BOA GENERAL REVIEW COVERSHEET RE-NOTIFICATION

CASE: C15-2020-0003

ADDRESS: 3409 Neal St

VARIANCE REQUEST (updated): reduce minimum lot width from 50 ft. to 33.59 ft.

3409 NEAL STREET
RESUBDIVISION OF EAST ONE-HALF
OF LOT 3, BLOCK A, CHERICO SUBDIVISION
TRAVIS COUNTY, TEXAS

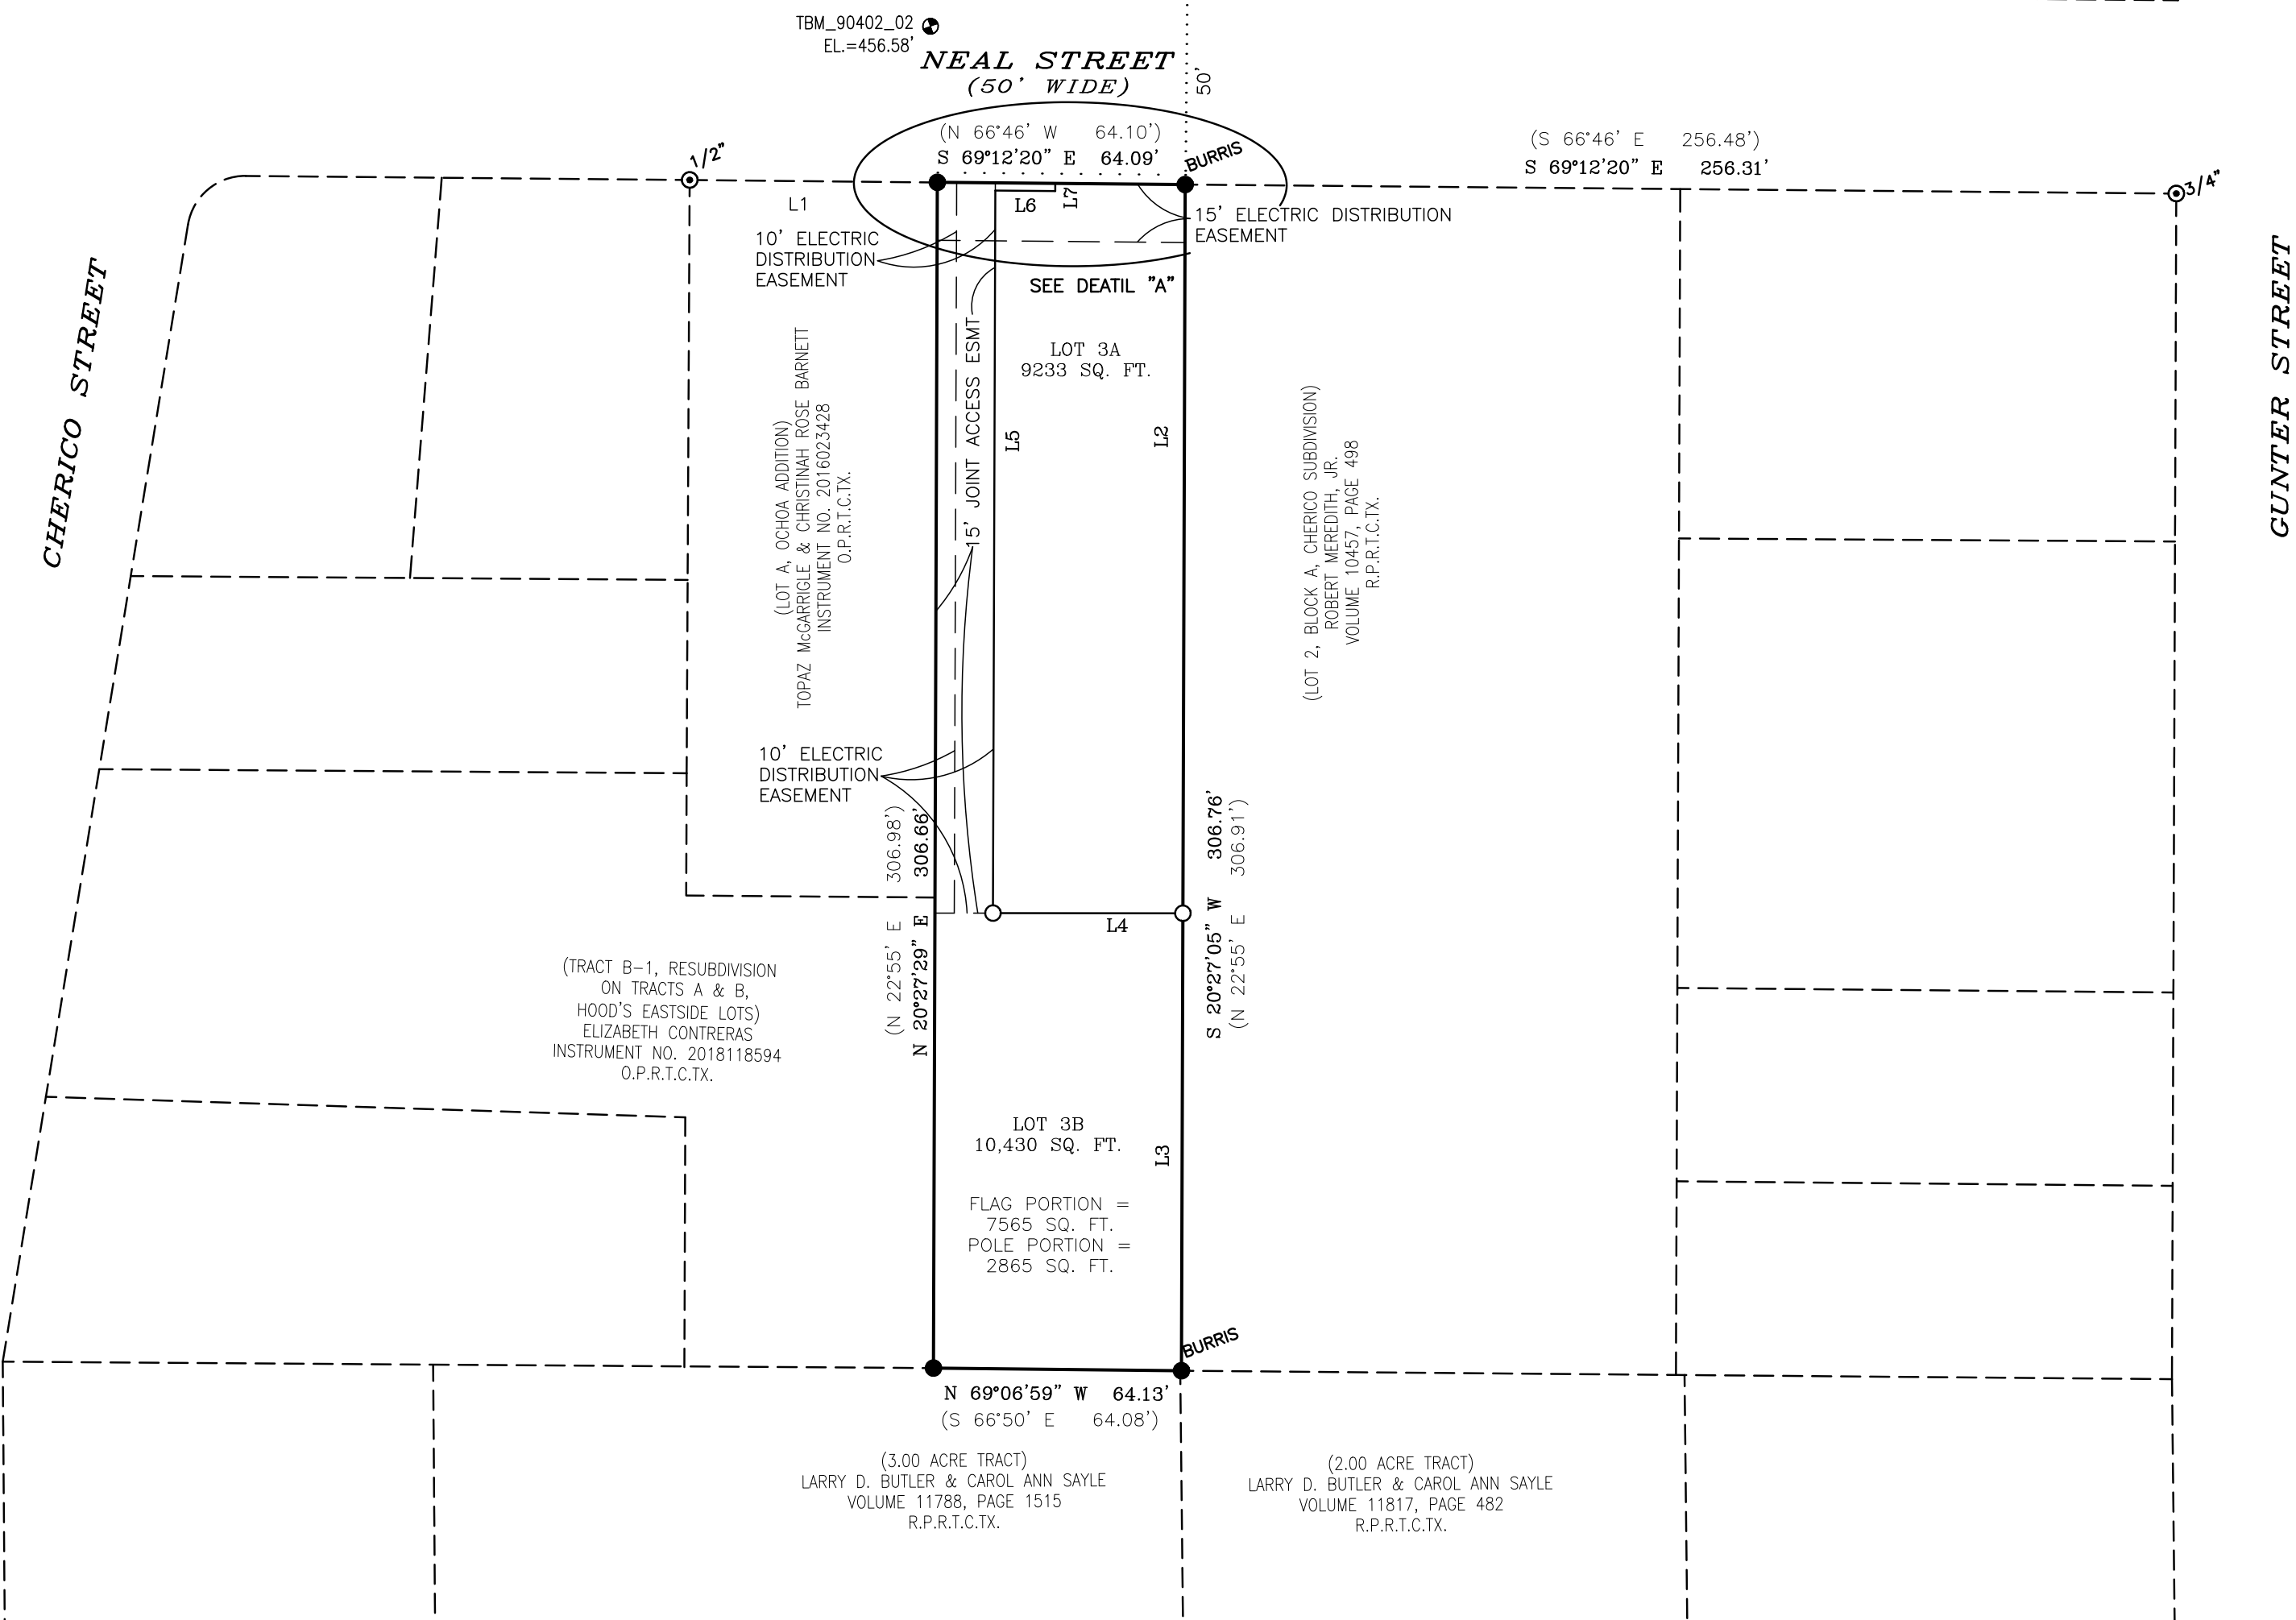
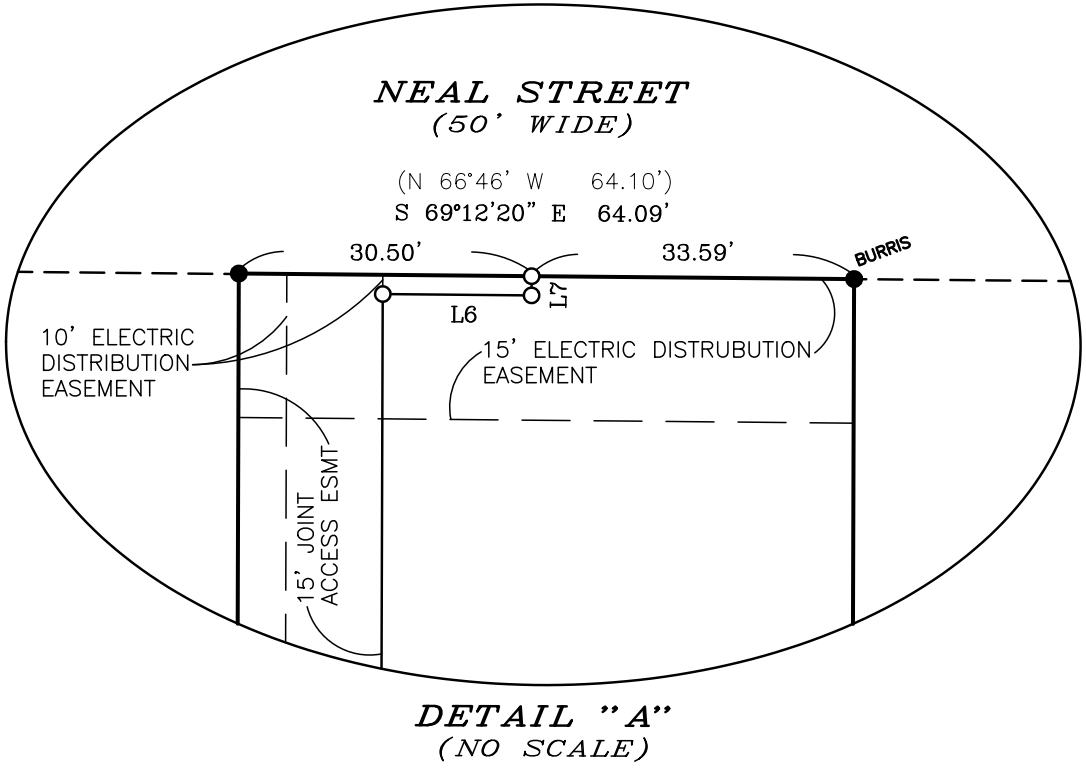
EL2. Provide a large sheet (24X36) of the driveway plan and profile plan. AW and AE do not share trenching. Provide utility assignments showing the electrical service to the back lot with a 10 ft. electrical easement and AW will need their own easement and provide AW's approval of separation from AE trenching. Plans are not readable.

UPDATE3: On a phone call the applicant was to verify their disconnect will be along the ROW for the flag lot with their MEP. Electrical Easement within the development is shown for the flag lot and private W/WW are shown within it. Not allowed.

PERMIT PARTNERS/AERPARMIA RESPONSE: SEE ATTACHED REVISED PLAT AND UTILITY PLAN. PLEASE EMAIL EITHER MIA OR I DIRECT IF THERE ARE STILL CHANGES NEEDED ON THIS PLAN – MPARTON@AEPARMIA.COM OR JENNIFER@PERMIT-PARTNERS.COM

REASONING BEHIND ADDING THIS EASEMENT & IN ORDER TO CLEAR EL2 COMMENT:

Per Bowman - according to her images, Karen thought the private w/ww lines were in the AE easement because of how the plat was drawn up. Editing it to show the 5' gap between the fence and the easement shows the lines are fine.
